Contract #: **04-0120E4**Cty **SF** Rte **80** PM **13.4,13.8**File # **13.25 B****QUALITY ASSURANCE - NONCONFORMANCE REPORT****Location:** Vancouver, WA.**Date:** 8/25/2006**Prime Contractor:** Kiewit, FCI & Manson Joint Venture**NCR #116****Submitting Contractor:** Oregon Iron Works**Type of problem:****Welding**  **Concrete**  **Other** **Welding:**  **Curing:**  **Procedural:**  **Bridge No.** 34-0006**Joint fit-up:**  **Coating:**  **Other:**  **Component:** E2**Procedural:**  **Procedural:** RECEIVED  
005176 SEP-19

Subject: Response to Submittal No. 884, Revision No. 00 (Oregon Iron Works Response to METS NCR #116 (QA/QC Issue #47))

## KFM SUBMITTALS FOR OREGON IRON WORK'S (OIW) RESPONSES TO NCRs

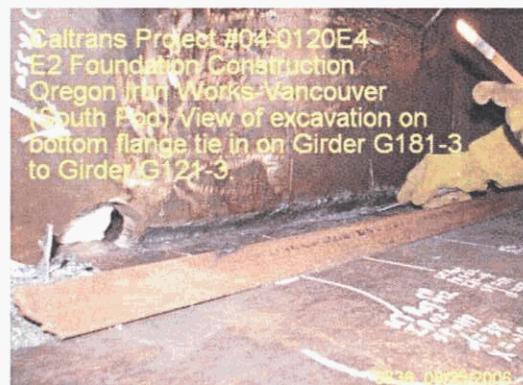
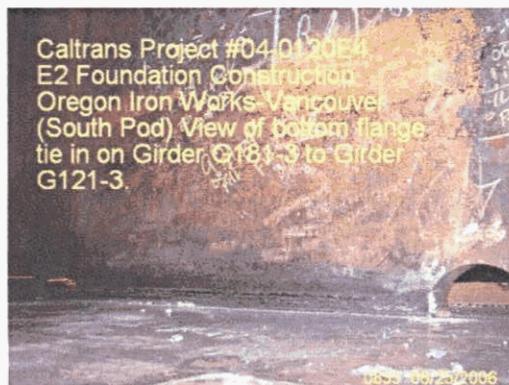
**Description of Non-Conformance:** Oregon Iron Works (OIW) Quality Control allowed OIW Welder Ron Bauer welder identification B-43 to perform a critical weld repair without receiving the Engineers approval. This was performed on Interior Longitudinal Girder Inter -Tie Girder G181-3 to Interior Transverse Girder G121-4 weld. The weld was excavated form one side, welded, and excavated beyond exceeded 65% of the specified weld size from the other side. OIW Quality Control was unaware that this repair exceeded non-critical requirements. *Attached pictures from this observation.*

**Applicable reference:** AWS D1.5-2002, Contract 04-012024 Special Provisions- Welding Quality Control Plan Requirements, note P.

**Contractor's proposal to correct the problem:** No corrective proposal has been submitted at this time.

11. NCR 116 was issued to document the Contractor proceeding with a CWR without approval by the Engineer. In accordance with OIW's response letter to NCR 116, dated September 7, 2006, METS understands that OIW proceeded with the G181-3/G121-3 connection as a result of a misunderstanding that it had been approved

with multiple other repairs that had been submitted the same day. METS believes this to be an isolated instance and does not expect it to be a reoccurring issue as the Contractor typically obtains approval before proceeding with CWRs. METS considers this NCR to be resolved at this time.
